Comment Response Letter

Project Name: Alworth

Project Log Number: DSRFY2024-0003

The following in response to the Draft Staff Report dated December 27, 2023. Highlights are from the Staff Report.

L100

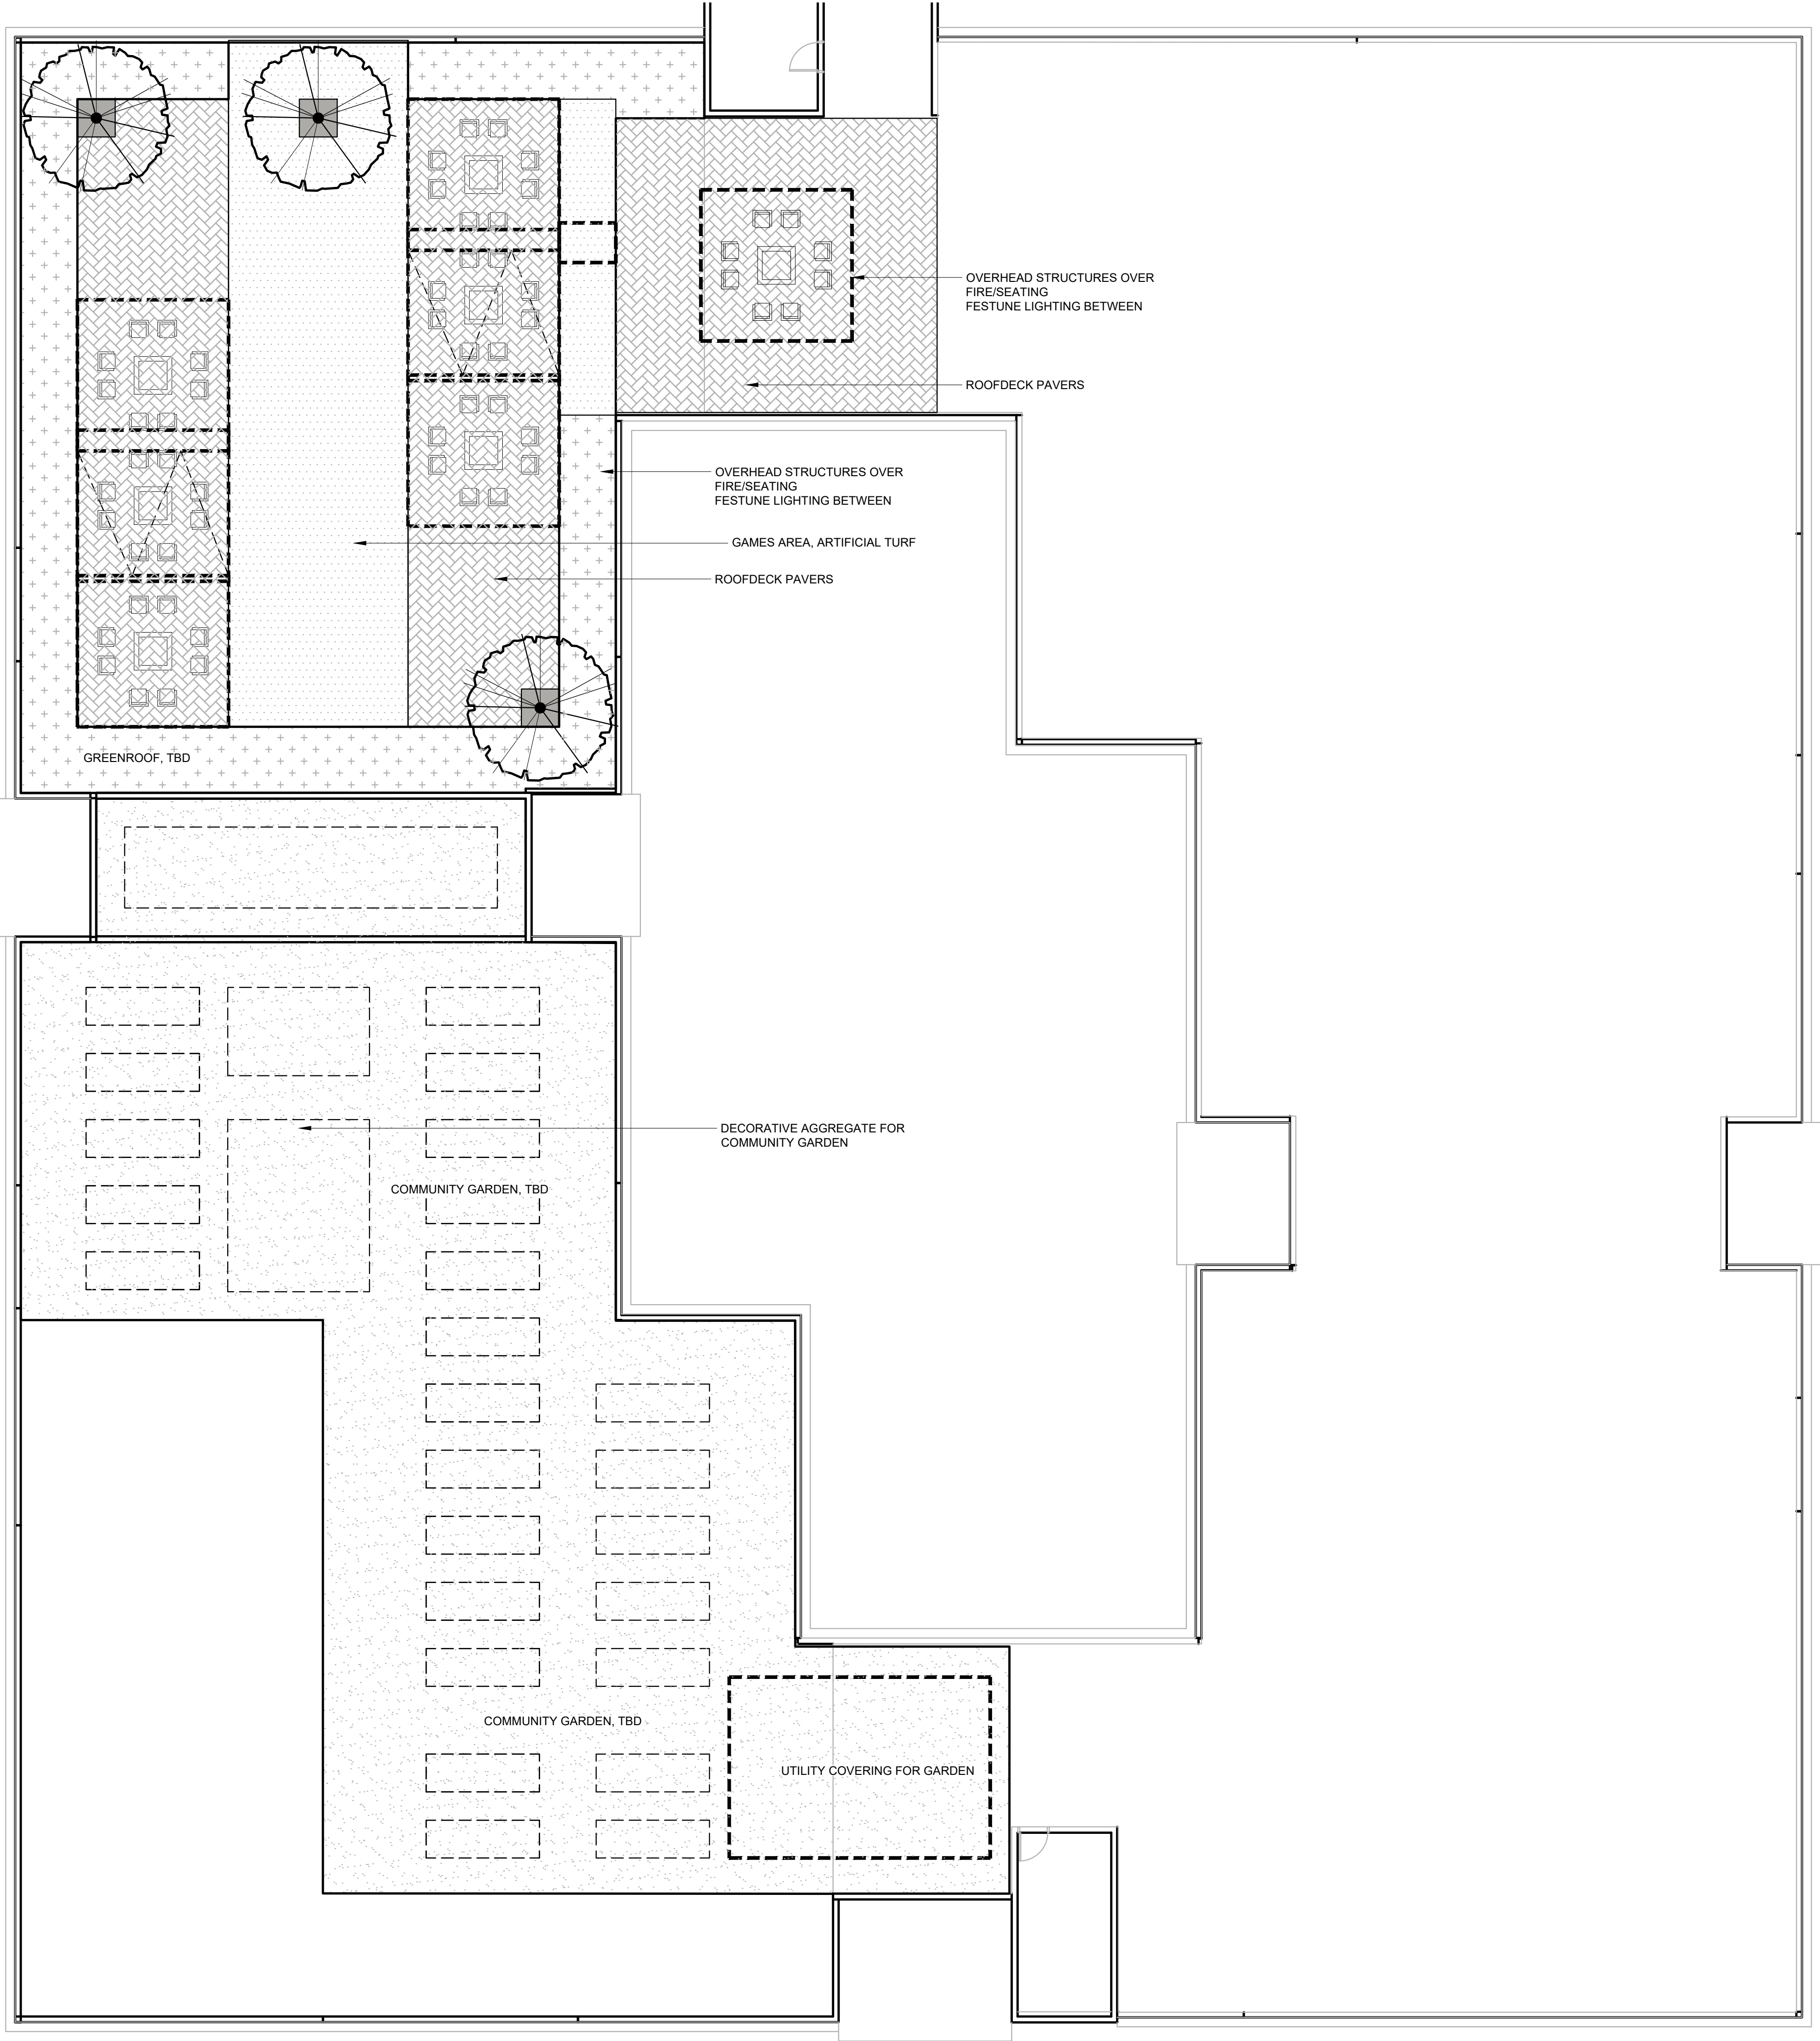
- b. Information mismatch between plans. In plan L100, a pedestrian path is indicated on the western side, while plan A100A does not indicate that there is a pedestrian connection there. In addition, Plan A100A indicates that there is no pedestrian connection within the site on the east side and is only via the sidewalk.

Response: A walkway is not provided on the west side of the building, refer to updated landscape plans. The land on the east side of the property is owned by the city and thus the pedestrian connections are minimal.

A100

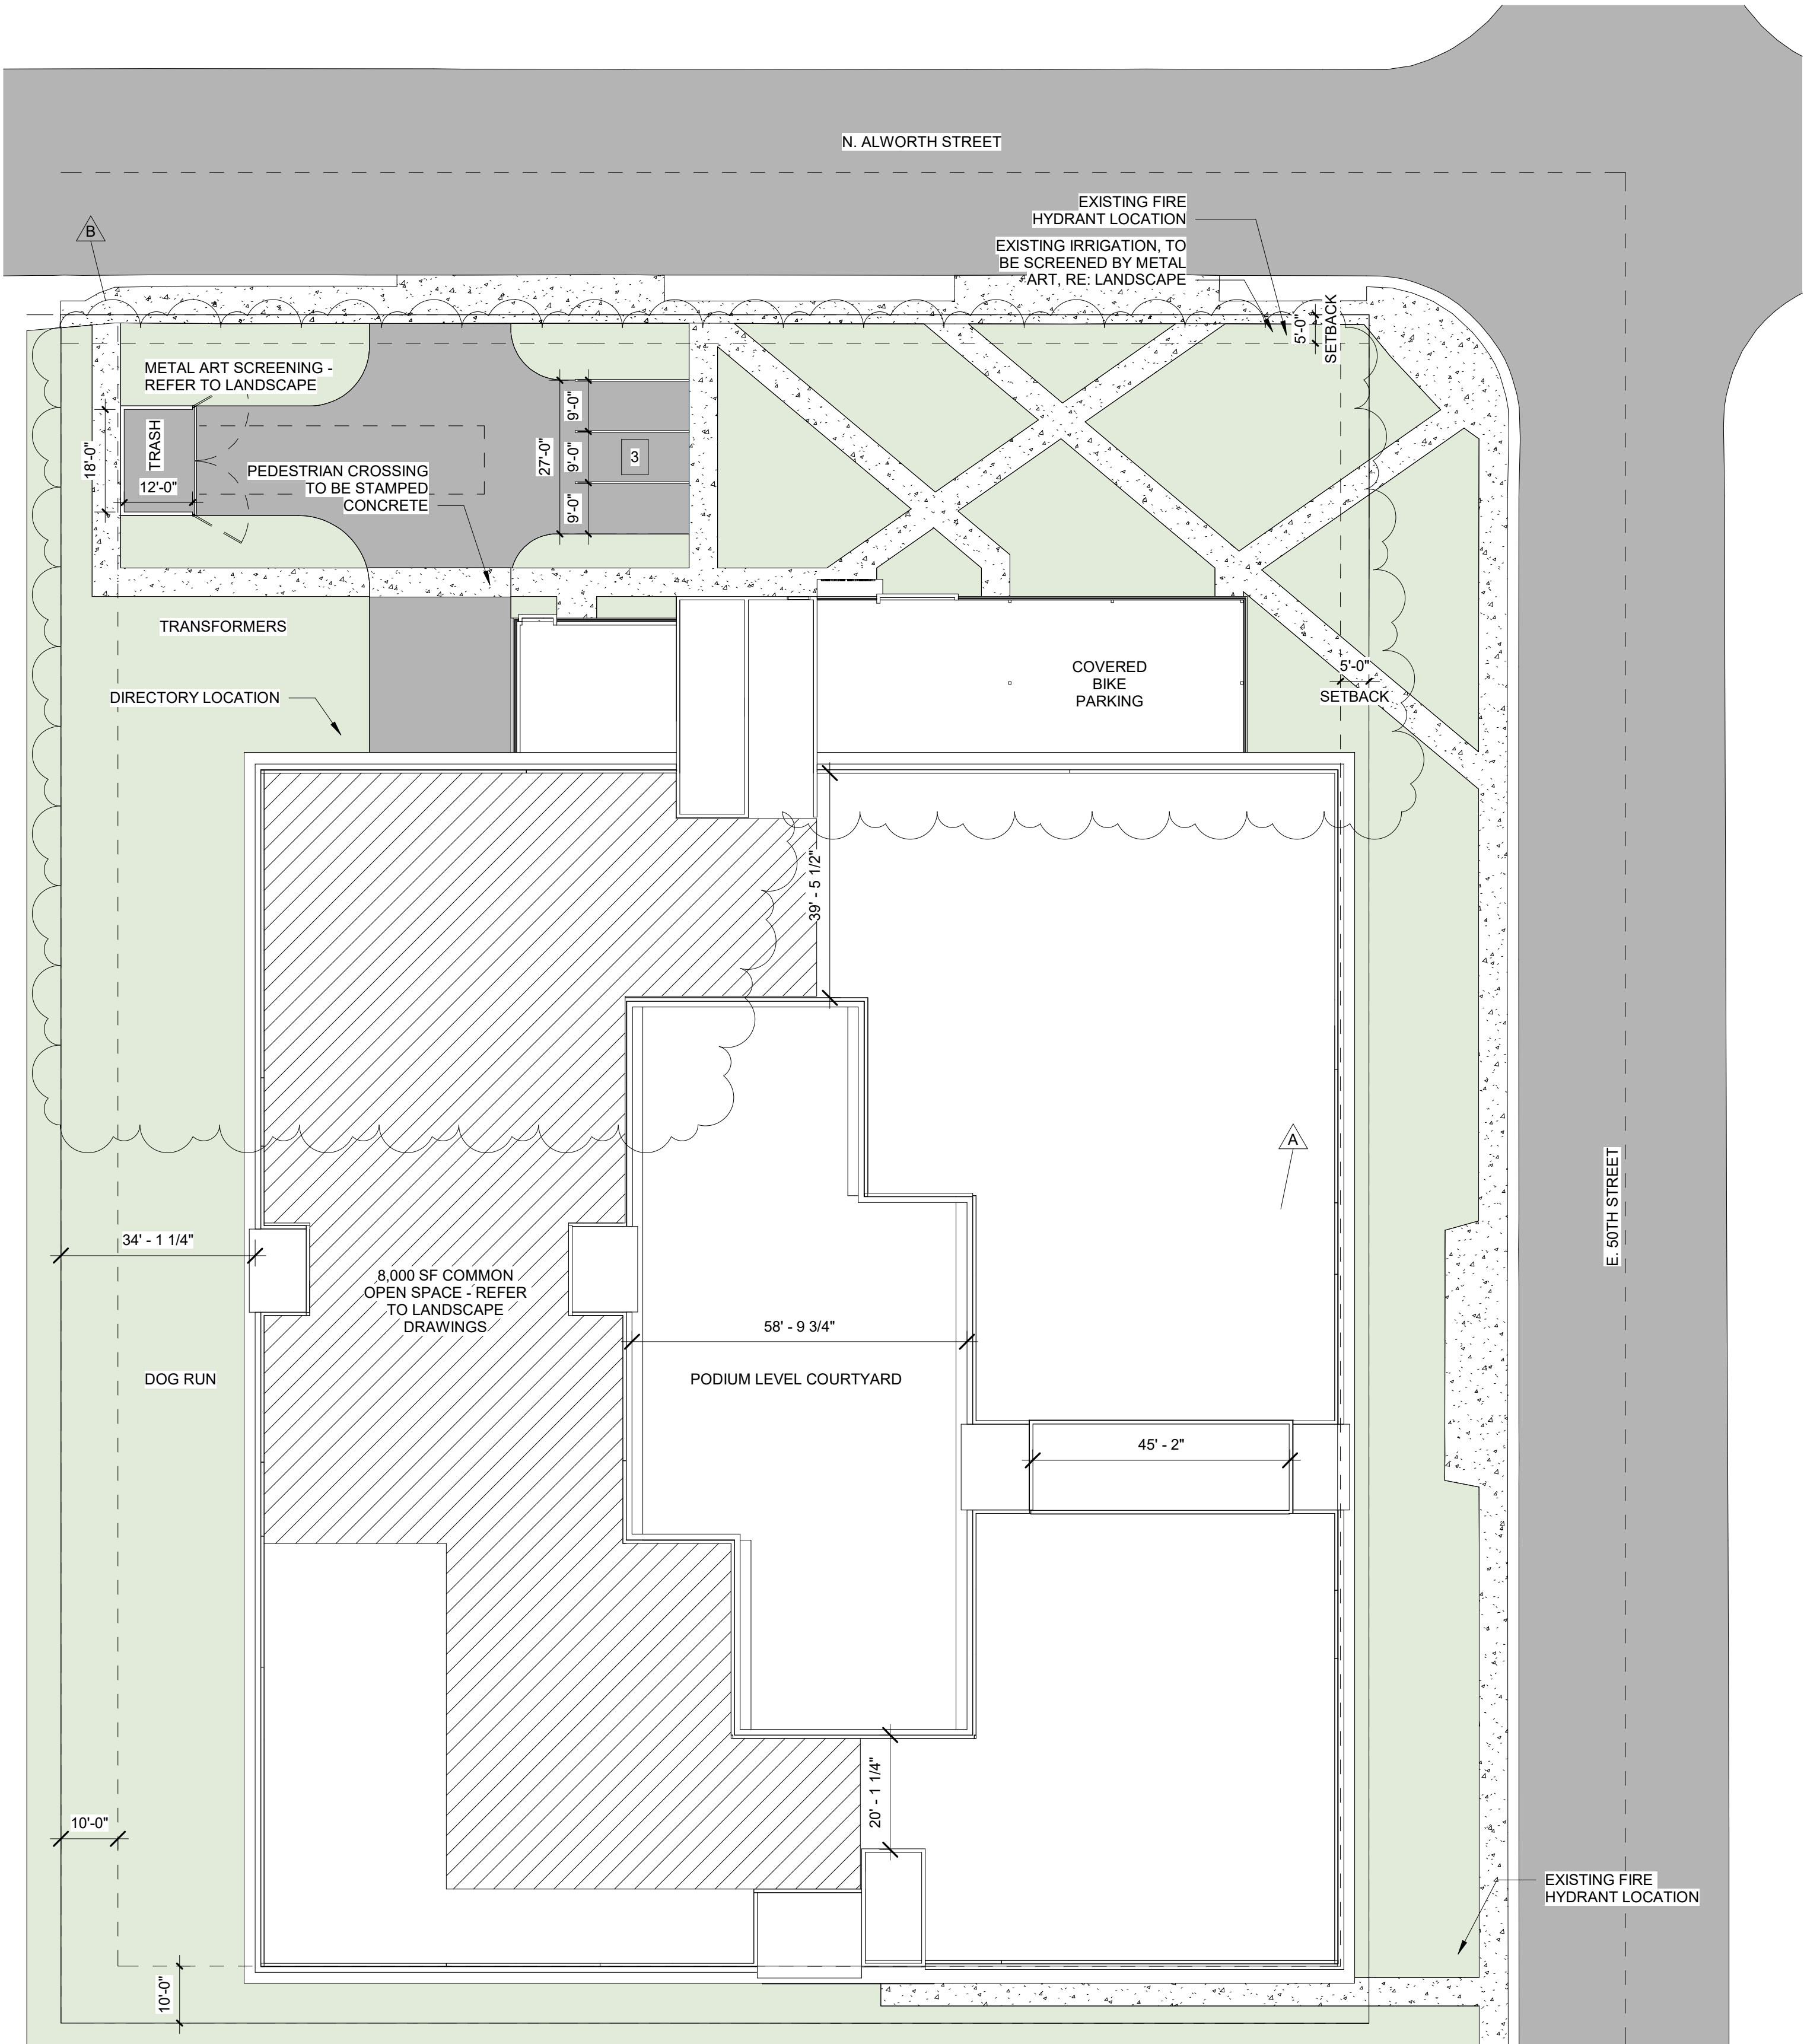
- c. On December 22, 2023, the applicant made changes to the new plans in which the loading area was replaced by parallel parking. The plans do not specify the size or number of new parking spaces. Also, the data in other plans was not updated, for example on Site plan A100. It is necessary to clarify the size and number of parking spaces considering the changes.

Response: Additional changes were made to the site, eliminating the parallel parking area and adding 3 surface parking spaces. The site analysis chart on A100 has been updated to reflect this change.

Response: The total required open space is 28,500sf and the total provided is 28,925sf. Refer to Open Space Calculations on A100 and Open Space Exhibit on L102.
